# DEVELOPMENT SERVICES

## PLANNING AND ZONING BOARD STAFF REPORT

314 NE 3<sup>rd</sup> Avenue

Meeting	File No.	Application Type
October 21, 2024	2024-081-SPF-SPR-LV4	Level 4 Site Plan with CBD Waiver
Applicant/Property Owner		Authorized Agent
Ocean Parker Delray, LLC		Jeffrey A. Costello, AICP, FRA-RA

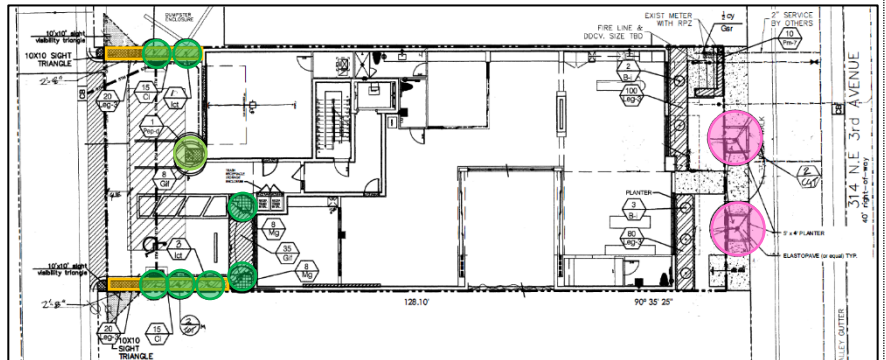
The proposed site plan generally meets all applicable requirements of the Land Development Regulations, other than the specifically identified waivers. The site is configured with a lobby entrance for the ground floor office facing NE 3<sup>rd</sup> Avenue and the second-floor residential unit is accessible from the rear alley. The parking spaces for the residential unit are located in the rear as a private garage and the ground floor office is not required to provide parking. This configuration helps alleviate the negative visual impact that results from an abundance of visible off-street parking placed between the buildings and public realm. The site configuration proposes a well-landscaped streetscape along NE 3<sup>rd</sup> Avenue and the proposed streetscape aligns with the recent streetscape improvements from the City funded public improvement project.
